Memorandum

Subject: Parker and Pine Multifamily Filing 1 AMD2 Lots 1-3 – Engineering 1st Review

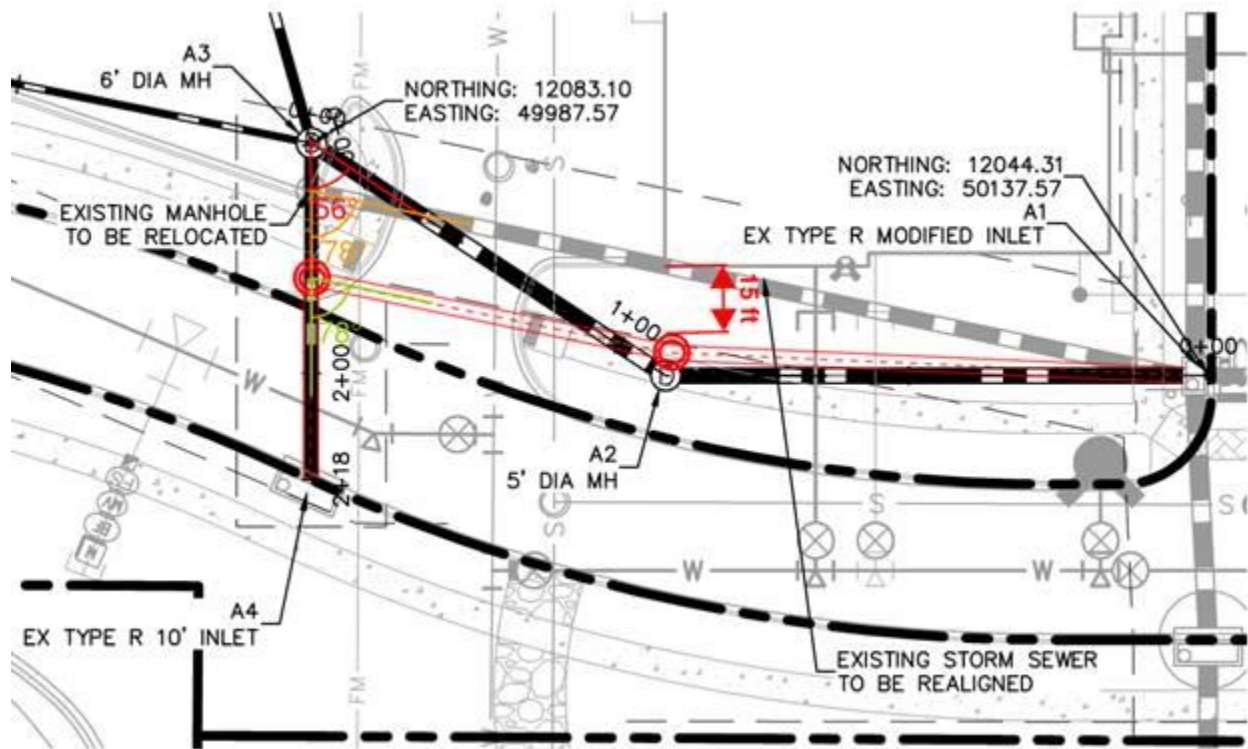
8. **SHT C5.4:** The revised location of MH A3 exacerbates the acute angle between incoming flows from Inlet A4 and the downstream connection to MH A2 – from $\approx 78^\circ$ to $\approx 56^\circ$. Reconfigure to at least match the existing acute angle. One possible reconfiguration is shown below.
